SUBJECT: **NEW VEHICLE DEMONSTRATION / DELIVERY HOLD - Safety Recall 16S18 - Supplement #4**
Certain 2014-2015 Model Year Explorer and Police Interceptor Utility Vehicles
Rear Suspension Toe Link Replacement

New! REASON FOR THIS SUPPLEMENT

Attachments: Attachment IV has been added to provide direction regarding installation of aftermarket ball joints/bushings.

NOTE: The toe links must be secured at ride height during replacement. See Figure 1.

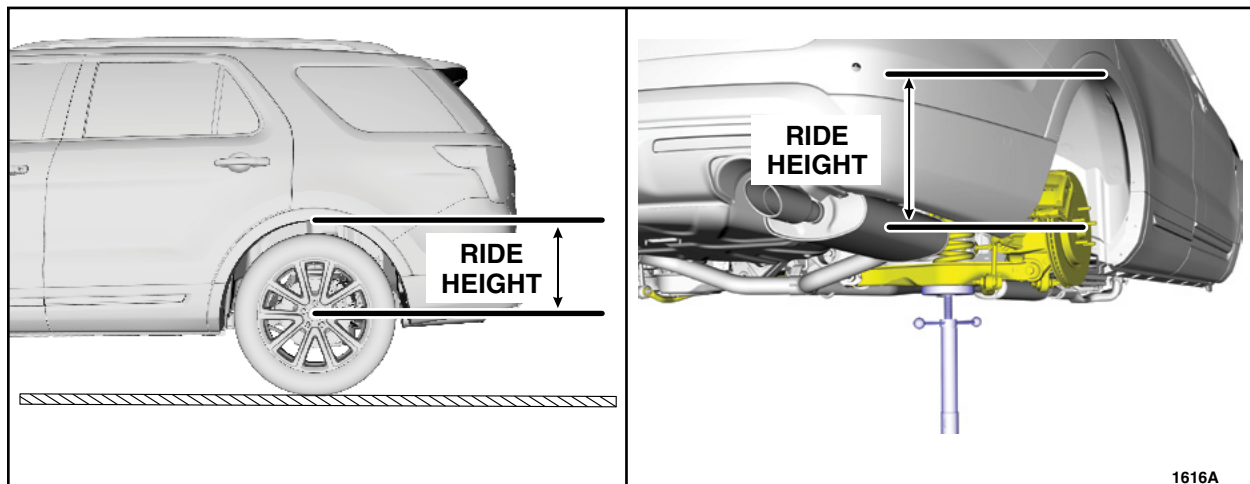
⚠ WARNING: Suspension fasteners are critical parts that affect performance of vital components and systems. Tighten fasteners as specified. Measure the distance from the center of the wheel hub to the lip of the fender with the vehicle in a level, static ground position (ride height) before disassembly. When securing the *new* toe link, it must be secured at the previously measured ride height.

⚠ WARNING: Tighten the suspension bushing fasteners with the suspension supported at ride height or with the weight of the vehicle resting on the wheels and tires, otherwise toe link and bushing damage may occur.

1. Replace both rear toe links and all fasteners. Please follow the Workshop Manual (WSM) procedures in Section 204-02.

NOTE: The new toe link adjustment sleeve jam nuts are only finger tight. The jam nuts must be tightened to the torque specification in the WSM even if toe adjustment is not necessary.

KNUCKLE BALL JOINT/BUSHING LOCATIONS

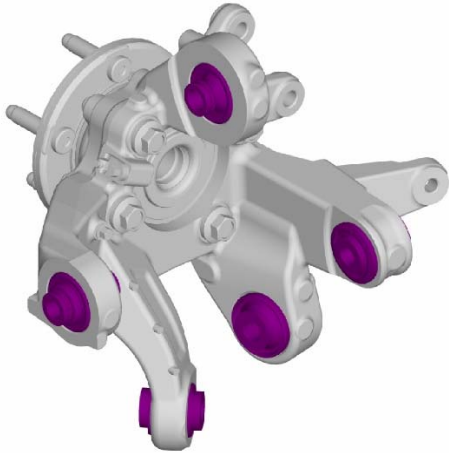
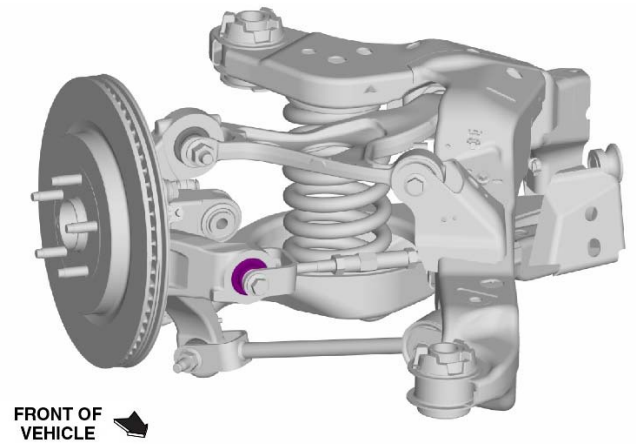
Ford has received reports of toe link failures on customer vehicles after the installation of non-OEM cross-axial ball joints (aka bushings) in the rear wheel knuckle. Installation of aftermarket bushings rather than replacement of the rear wheel knuckle assembly is not recommended, as this may limit the movement of the joint and cause stress on the toe link. In the reports that Ford received, the toe links failed shortly after installation of an aftermarket bushing installed by the dealership.

Dealerships may have serviced rear wheel knuckles, including use of aftermarket bushings, as part of preventive maintenance. These inspections and maintenance services sometimes took place as a separate customer paid repair when the vehicle was being serviced for the following FSAs: 19S17, 17G01, 16S18. Because these repairs would occur as a customer paid repair directly to the dealership and not submitted to Ford for reimbursement, Ford does not have a record of how many of these repairs may have occurred.

If 2011-2019 Ford Explorers or PIU vehicles require service of the rear wheel knuckle and/or rear wheel knuckle bushings, the recommended repair is to replace the affected rear wheel knuckle (5B758/9) as an assembly only. Refer to WSM, Section 204-02, and the Ford Service Parts Catalog as needed.

If your dealership performed repairs on the rear suspension of 2011-2019 Ford Explorers or PIU vehicles and installed aftermarket bushing(s) in the rear wheel knuckle instead of replacing the complete rear wheel knuckle assembly (at any time), you should identify all of the vehicles repaired with the aftermarket bushing(s), contact the customer, and replace the rear wheel knuckle as an assembly. Failure to do this may result in a toe link fracture. A fractured rear toe link will cause a sudden change in vehicle handling and increase the risk of a crash.
